Casady Short Plat

DEVELOPMENT STANDARDS
CASE NO.: SPL06-00014
PCD FILE NO.:SPL06-00014

Project Name: Casady Short Plat
Project Address: 9216 and 9222 112th Ave. NE
Date: July 12, 2006

File: Casady Short Plat, File No. SPL06-00014

FOR: PRELIMINARY SHORT PLAT
CASADY ENTERPRISES, INC
PO BOX 3475
KIRKLAND, WA. 98083

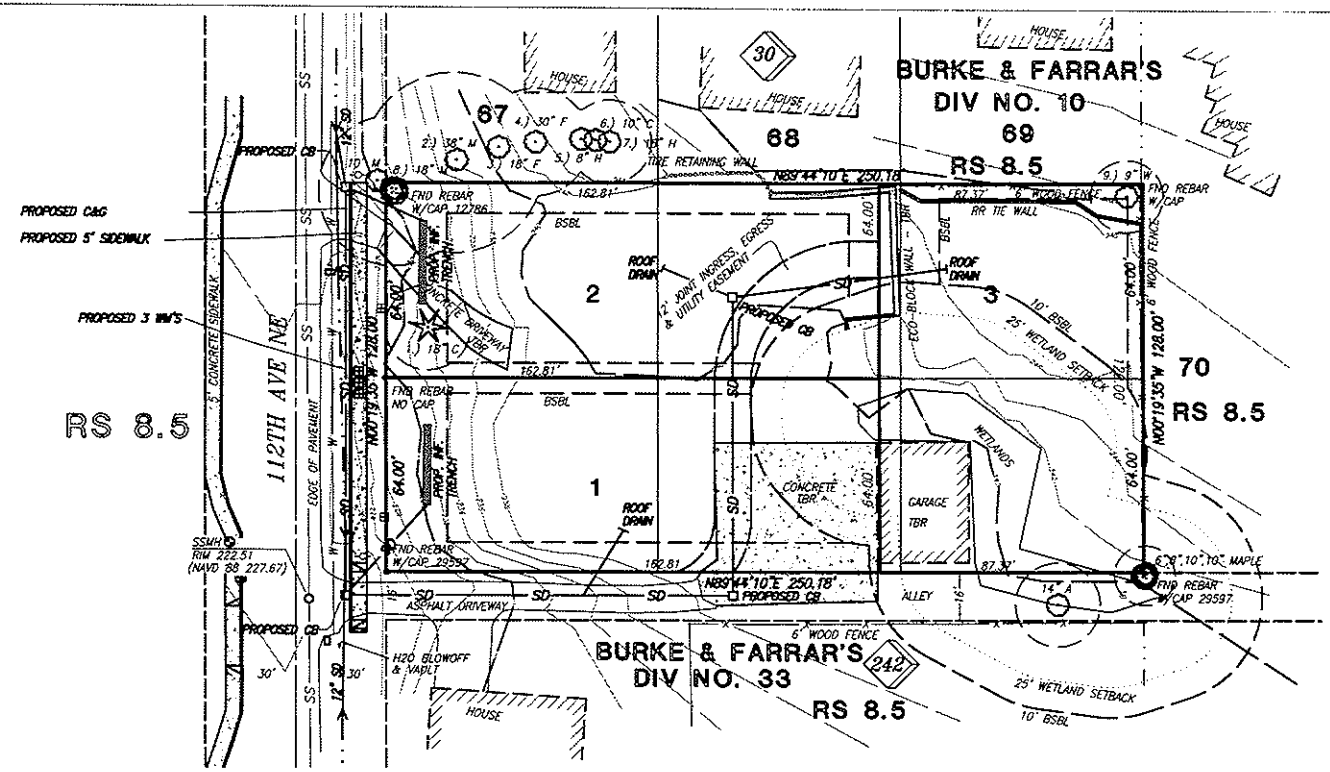
--The location of the single family homes shown appear to be in compliance with the IRC requirement.
